**CENTRAL UTAH WATER CONSERVANCY DISTRICT  
CWP HIGH HEAD WELL PUMP HOUSE PROJECT  
WELLS #7, #16, AND #17  
June 2, 2023**

**DOCUMENT 00 91 13.1  
ADDENDUM NO. 1**

PUMP HOUSE PROJECT WELLS #7, #16 & #17  
CIVIL  
WELL #7 SITE PLAN

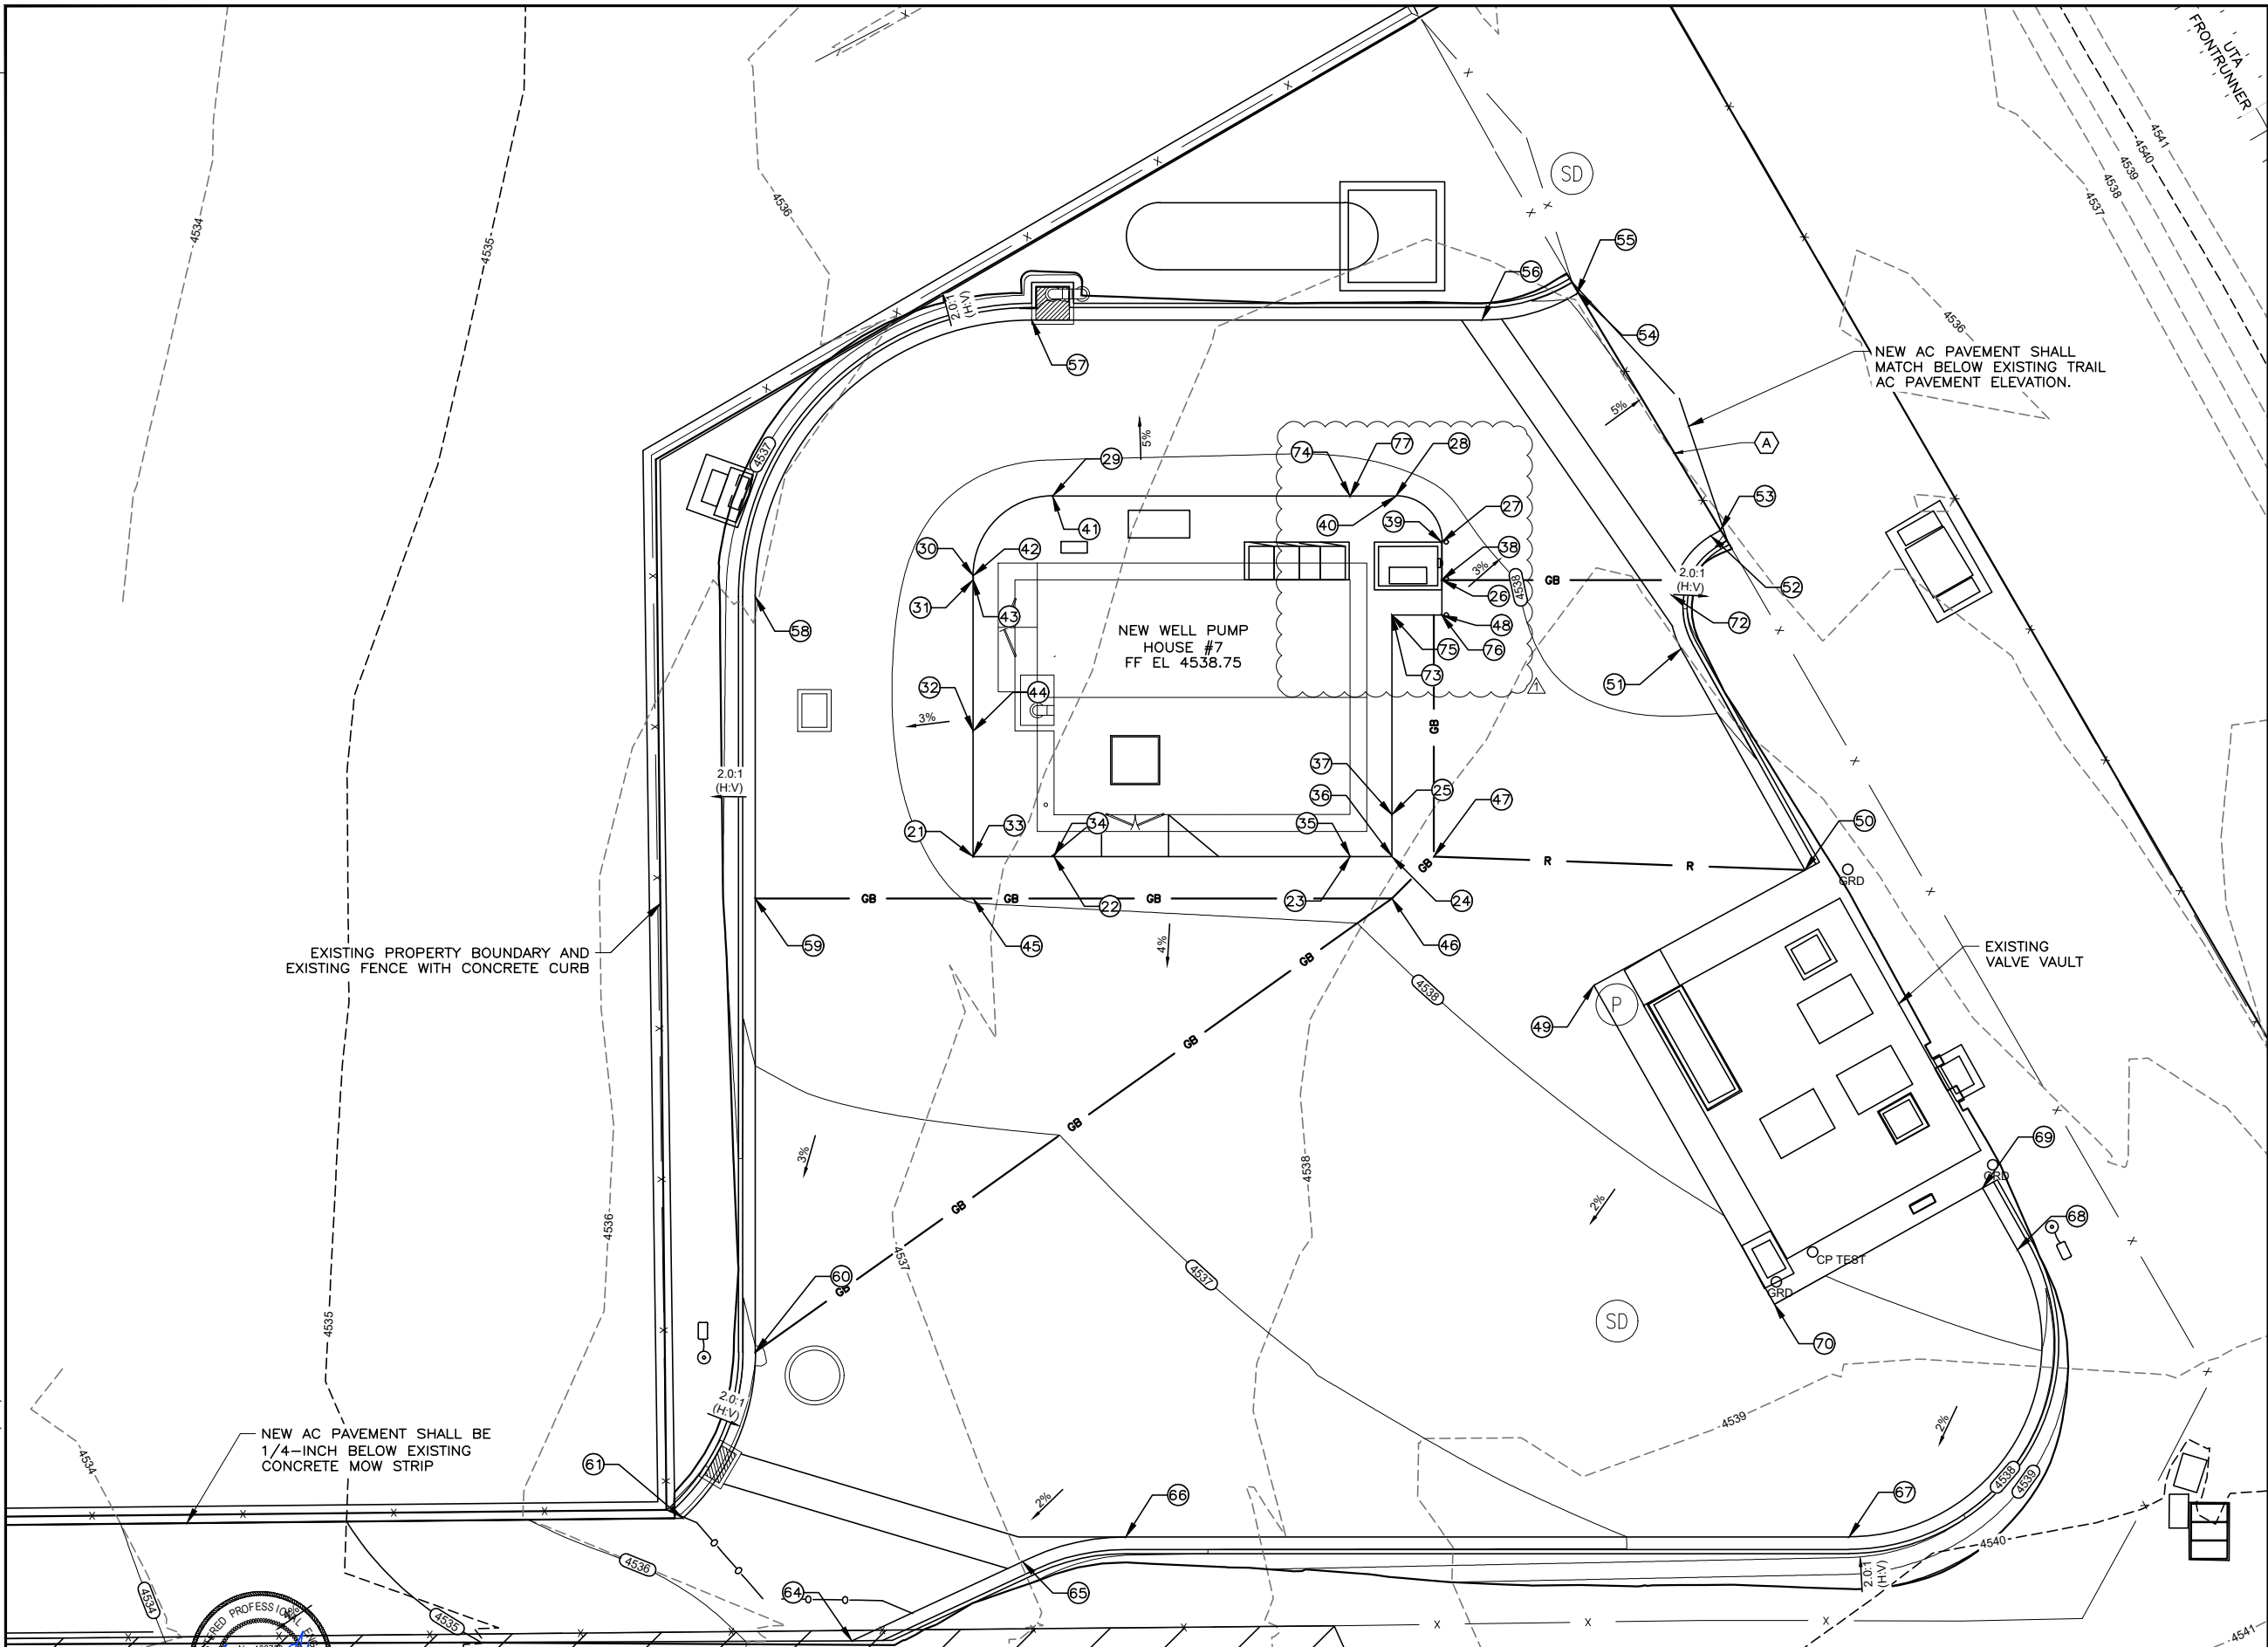
F. **Comment:** OWNER currently has camera poles at Wells 7 and 17. Poles consist of an I-beam 40' long, with 10' buried at Well 7 and Well 17. At the end of the project, CONTRACTOR shall remove both poles and salvage them to OWNER.

- (K) REMOVE I-BEAM CAMERA POLE AND DELIVER TO CUWCD MAINTENANCE YARD ON 1600 NORTH.

PUMP HOUSE PROJECT WELLS #7, #16 & #17  
CIVIL  
WELL #7 FLOOR PLAN

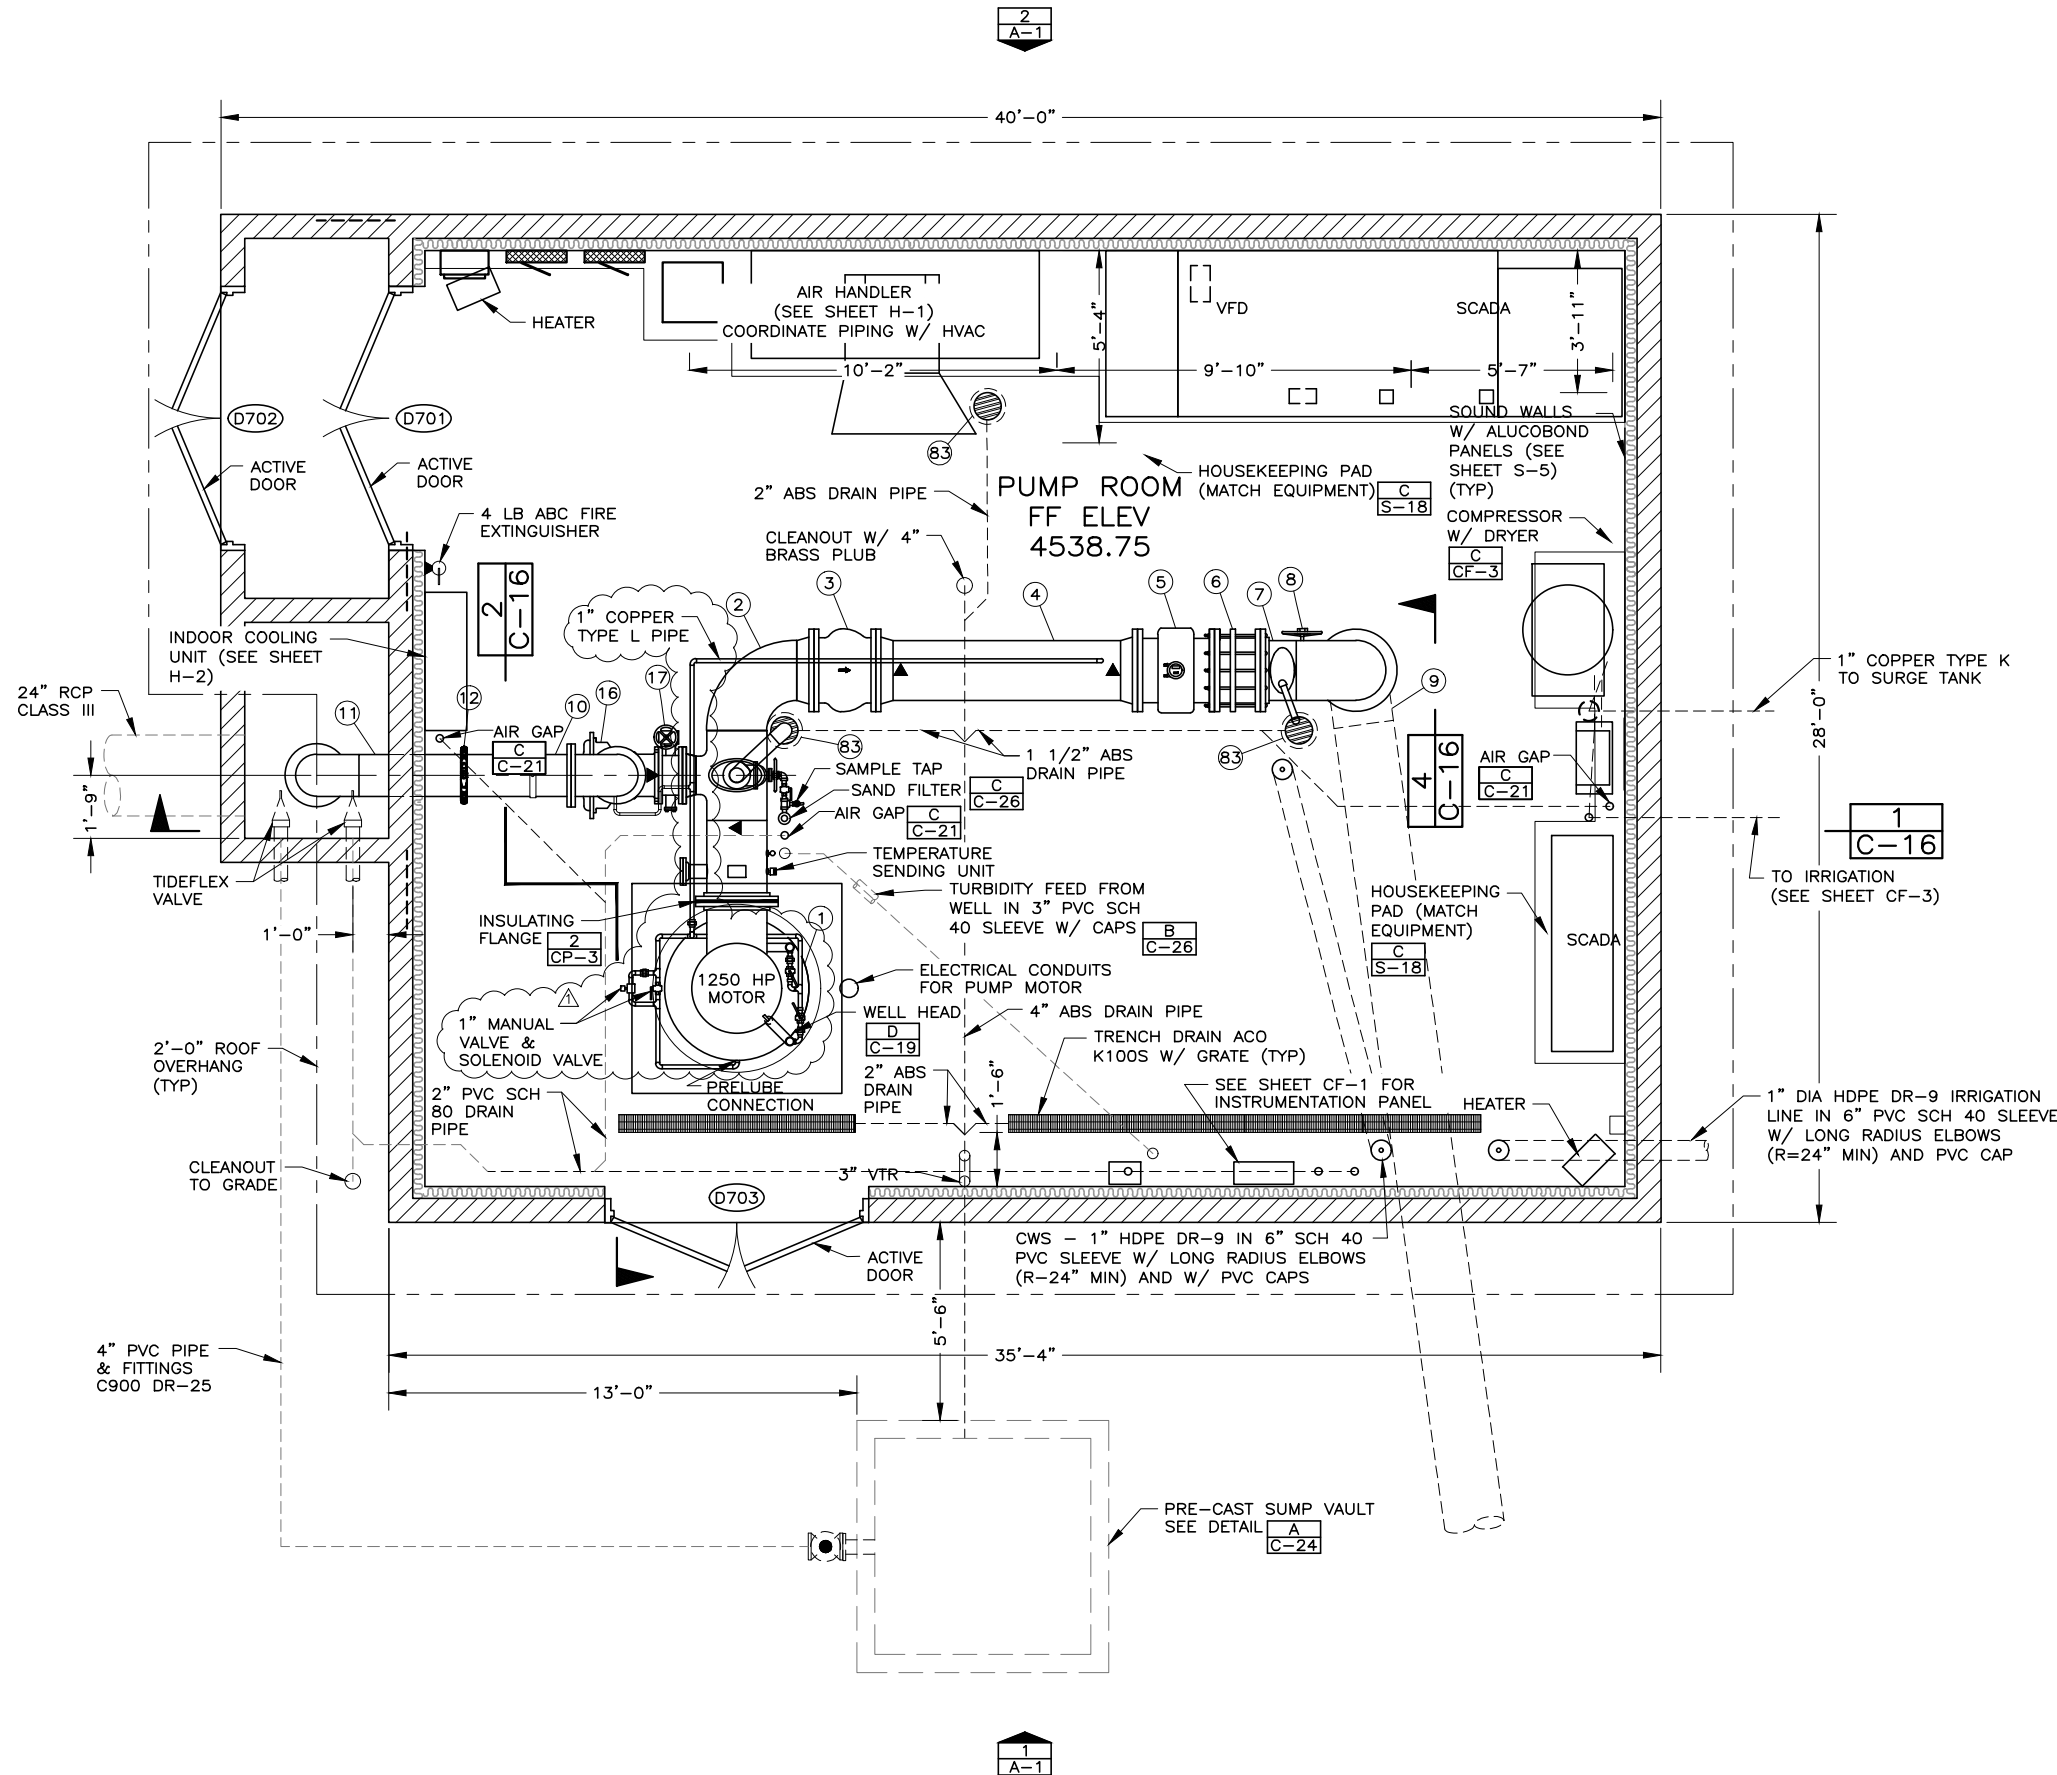
I. **Question:** On Sheet C-4 (Pumphouse #7) Are we running the 4" C900 pipe from the Sump Vault to the 60" manhole? There isn't anything on the plans.

**Response:** No, we are not running the Well 7 - 4" C900 pipe from the Sump Vault to the 60" manhole. Please see Drawing C-13 – Well #7 Floor Plan. The pipe runs to and discharges into the pump-to-waste box on the east side of the building at Well 7.
